Access Compliance Report Public Rights-of-Way (Curb Ramps)

Main Street: BOSTONIAN_DR Cross Street: MARTHA_ANN_DR Location: S

ADA ID: RPRK211220131153 Ramp Type: Type 4 - Parallel Initial Pass/Fail: Fail Overall Compliance: No Severity Score: 15

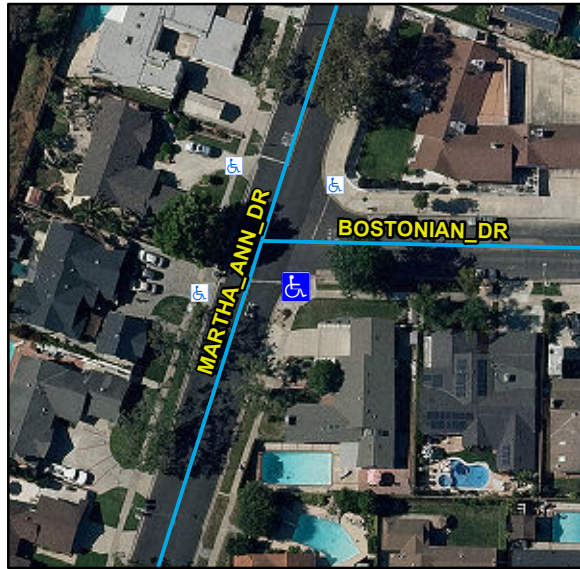
Compliance	Description	Data	Compliance	Description	Data
N/A	Ramp Length LT (in)	102	N/A	Ramp Length RT (in)	104
Yes	Ramp Width LT (in)	128	Yes	Ramp Width RT (in)	128
Yes	Ramp Run Slope LT (%)	3.7	Yes	Ramp Run Slope RT (%)	6.5
No	Ramp Cross Slope LT (%)	6.7	No	Ramp Cross Slope RT (%)	3.8
N/A	Landing Present	N/A	N/A	DWS Provided	N/A
N/A	Landing Length (in)	N/A	N/A	DWS Contrast	N/A
N/A	Landing Width (in)	N/A	N/A	DWS Length (in)	N/A
N/A	Landing Run Slope (%)	N/A	N/A	DWS Full Width	N/A
N/A	Landing Cross Slope (%)	N/A		DWS Offset Type	N/A
N/A	Landing Movement Obstructed?	N/A	N/A	DWS Offset Left (in)	N/A
	Landing Movement Type	N/A	N/A	DWS Offset Right (in)	N/A
N/A	Landing Shared	N/A			
N/A	Clear Space	Yes			
N/A	Clear Space To Crosswalk (in)	N/A			
N/A	Marked Crosswalk 1	No	N/A	Marked Crosswalk 2	No
	Crossing 1 Direction	NE		Crossing 2 Direction	NW
	Marked Crosswalk 1 Width (in)	N/A		Marked Crosswalk 2 Width (in)	N/A

Remove & Replace Curb Ramp With Two New Directional Ramps or Equivalent.
